Access Compliance Report

Public Rights-of-Way

(Curb Ramps)

Intersection ID: 2453	Main Street: CLARKE_CREEK_PY	Cross Street: BROOKINGS_DR	Location: SW
ADA ID: 7390C98F9D5F	Ramp Type: PerpDiag	Initial Pass/Fail: Fail	Overall Compliance: No
Severity Score: 8.75			
Codes/Mitigation Info/Possible Solution		Field Measurements/Component Compliance

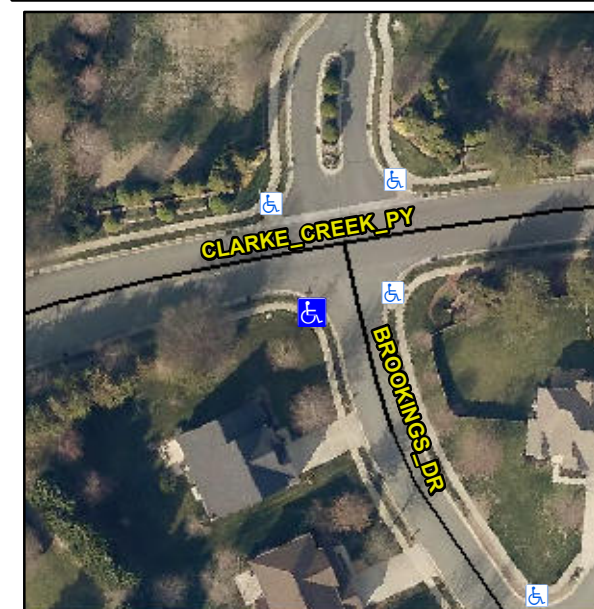
R304.5.1

Compliance	Description	Data	Compliance	Description	Data
N/A	Ramp Length (in)	51.0	Yes	Ramp Slope (%)	7.3
No	Ramp Width (in)	39.0	Yes	Ramp XSlope (%)	0.1
N/A	Flare Type LT	N/A	N/A	Flare Type RT	N/A
N/A	Flare Slope LT (%)	N/A	N/A	Flare Slope RT (%)	N/A
N/A	Flare Traversable LT?	N/A	N/A	Flare Traversable RT?	N/A
N/A	Landing Length (in)	N/A	N/A	DWS Provided?	N/A
N/A	Landing Width (in)	N/A	N/A	DWS Contrast?	N/A
N/A	Landing Slope (%)	N/A	N/A	DWS Length (in)	N/A
N/A	Landing X Slope (%)	N/A	N/A	DWS Full Width?	N/A
N/A	Landing Curb? (Y/N)	N/A	N/A	DWS Offset (in)	N/A
N/A	Shared Landing?	N/A			
N/A	Gutter Ponding?	N/A	N/A	Gutter Slope (%)	N/A
N/A	Gutter Lip Ht (in)	N/A	N/A	Gutter X Slope (%)	N/A
N/A	Painted X Walk1?	No	N/A	Painted X Walk2?	No
	X Walk 1 Direction	To E		X Walk 2 Direction	To N
N/A	X Walk 1 Width (in)	N/A	N/A	X Walk 2 Width (in)	N/A
	X Walk 1 Slope (%)	0.1		X Walk 2 Slope (%)	2.1
	X Walk 1 X Slope (%)	1.3		X Walk 2 X Slope (%)	2.9

Remove & Replace Curb Ramp With Two New Directional Ramps or Equivalent.
